PETITIONER: CHILDRESS - KLEIN PROPERTIES

SOUTH BOULEVARD: SECTION C
 ATTACHED TO ADMINISTRATIVE APPROVAL
 DATED: May 11, 1999
 BY: MARTIN R. CRAMTON, JR.

TECHNICAL DATA SHEET
 PETITION NO. 98-97
 FOR PUBLIC HEARING

SUBJECT: Administrative approval for Petition No. 98-97 Childress Klein Properties, Inc. Tax Parcels 123-041-14, 123-041-15-21 and 123-041-23.

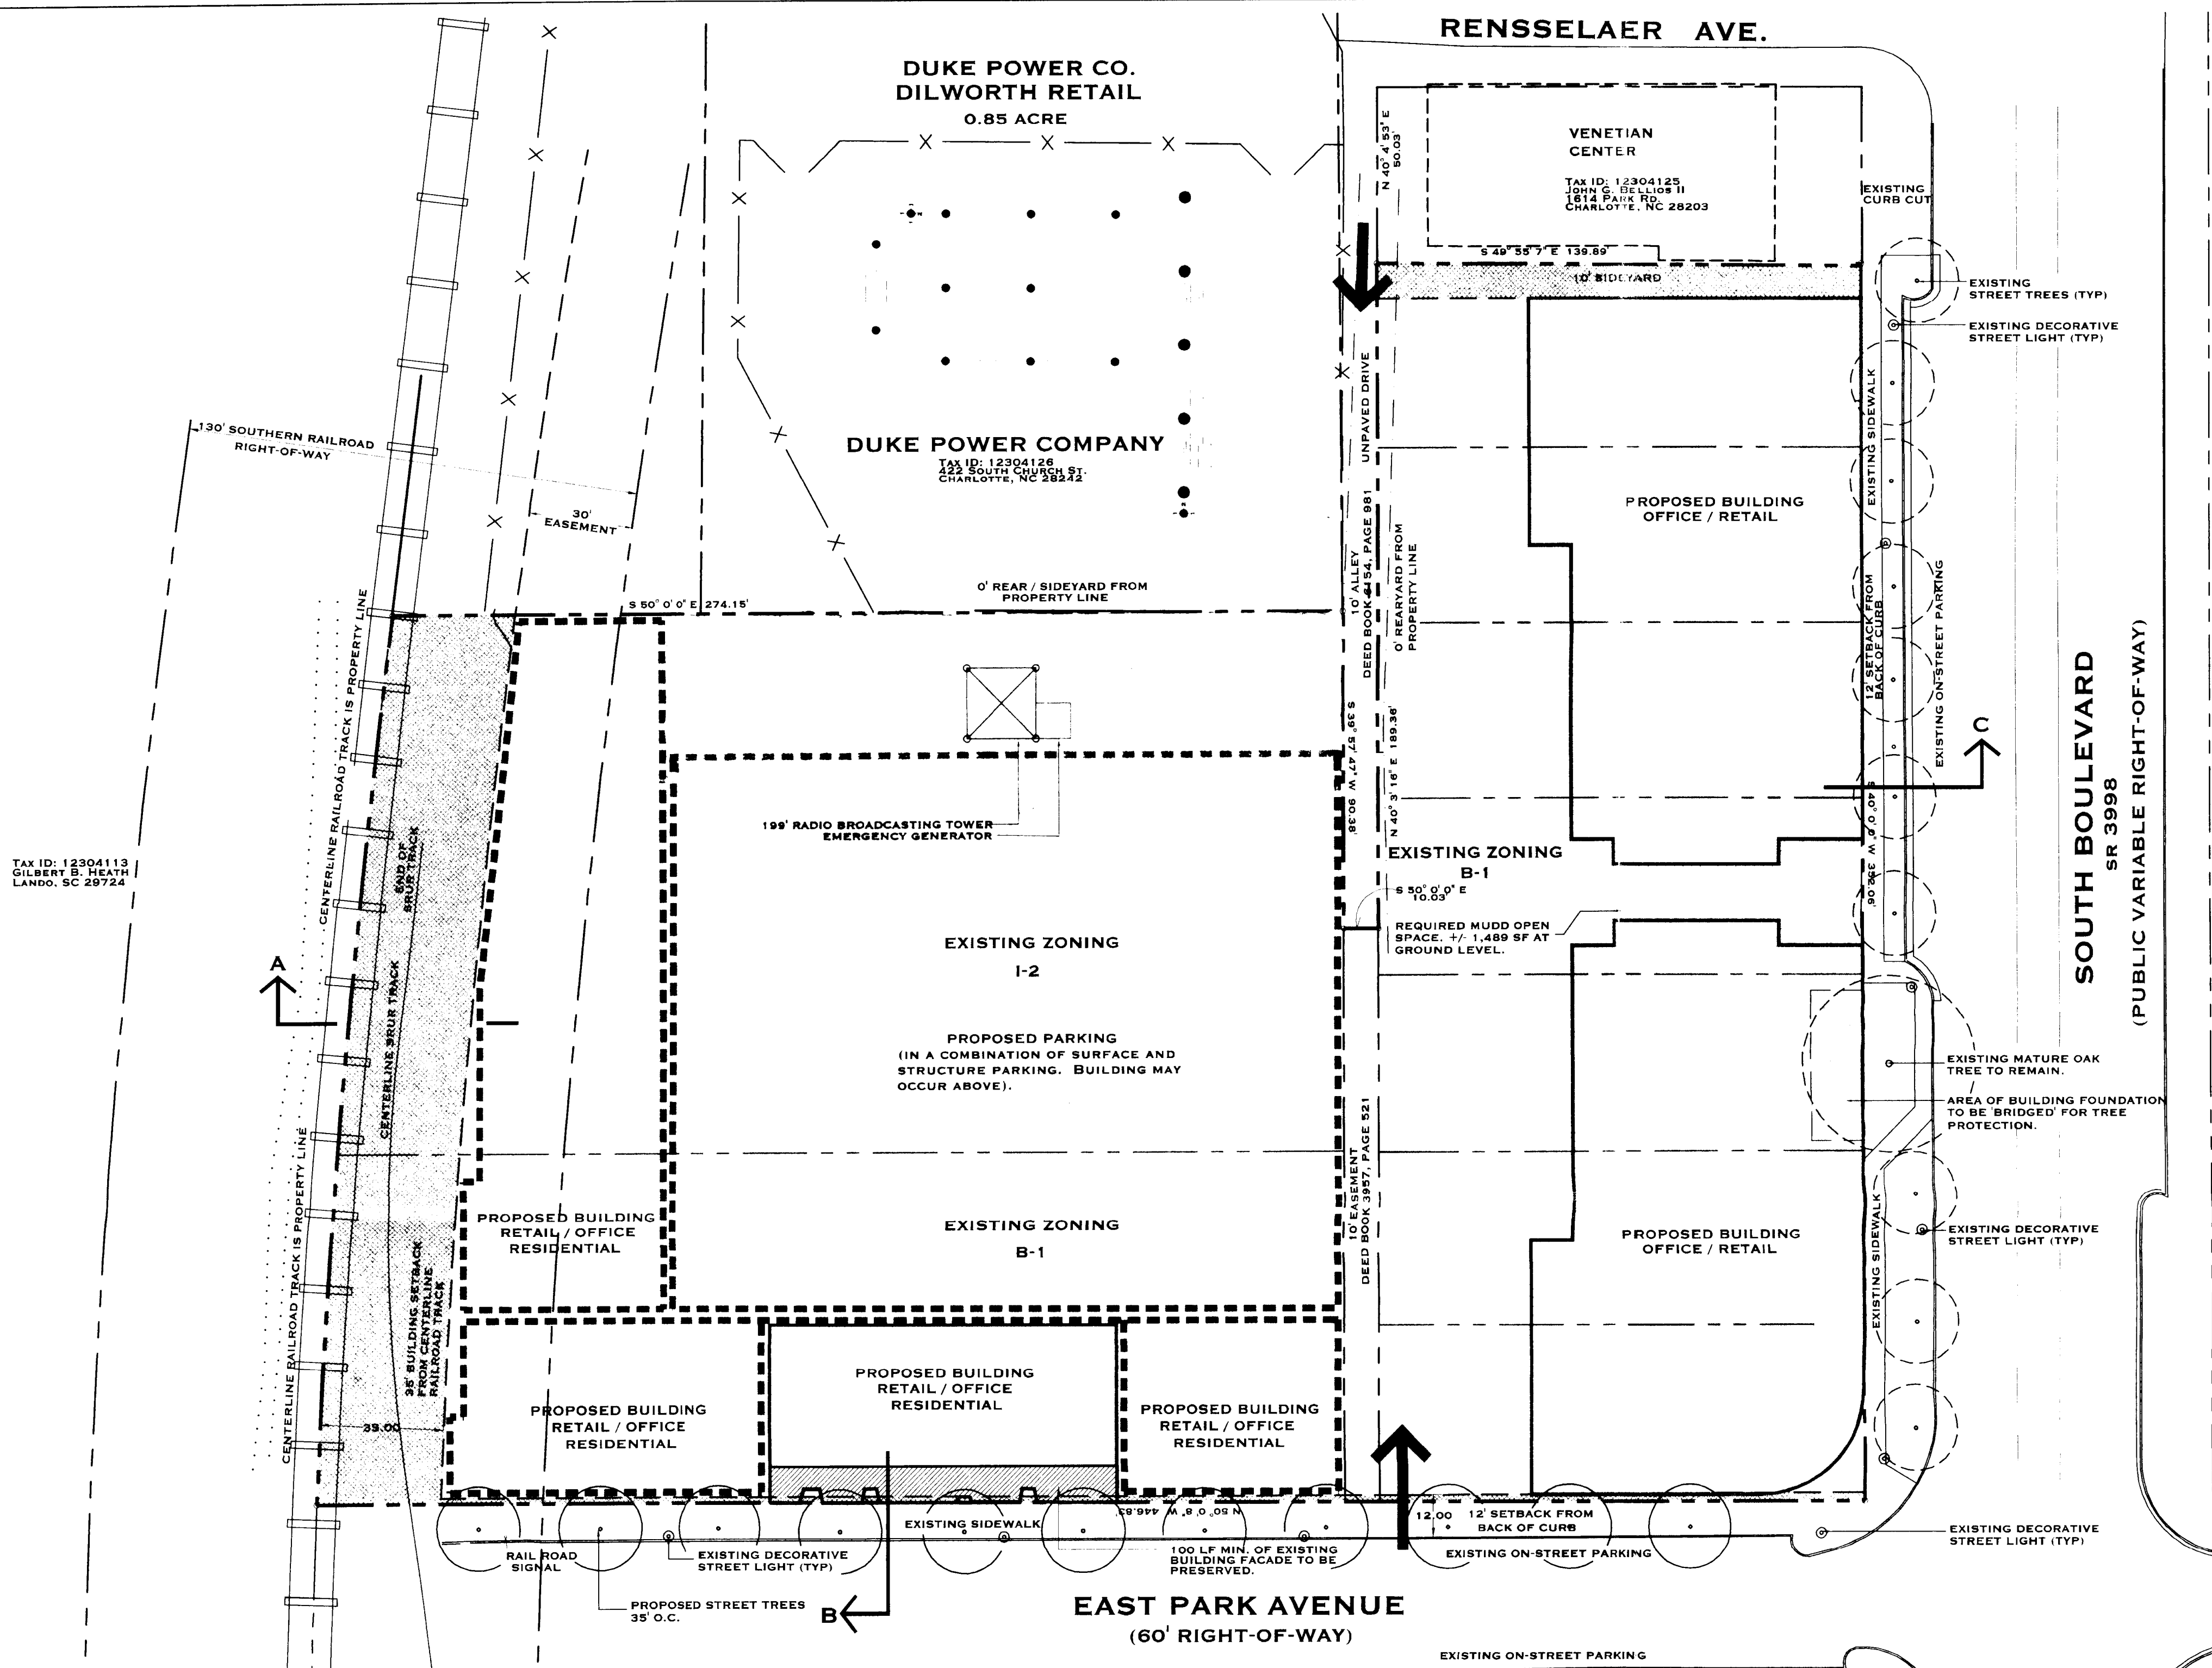
Land Design, Inc.
 DATE: JULY 24, 1998
 PROJECT NO. 18084
 \$9-18-98 PER CITY / CLIENT COMMENTS
 \$11-25-98 PER CITY / CLIENT COMMENTS
 \$4-23-99 ADD RADIO TOWER

Attached is a revised conditional plan for the above petition indicating the addition of a radio tower. Since a tower is an allowable use under the MUDD zoning category, I am administratively approving this request. Please use this revised plan when evaluating this site for building permits and certificate of occupancy.
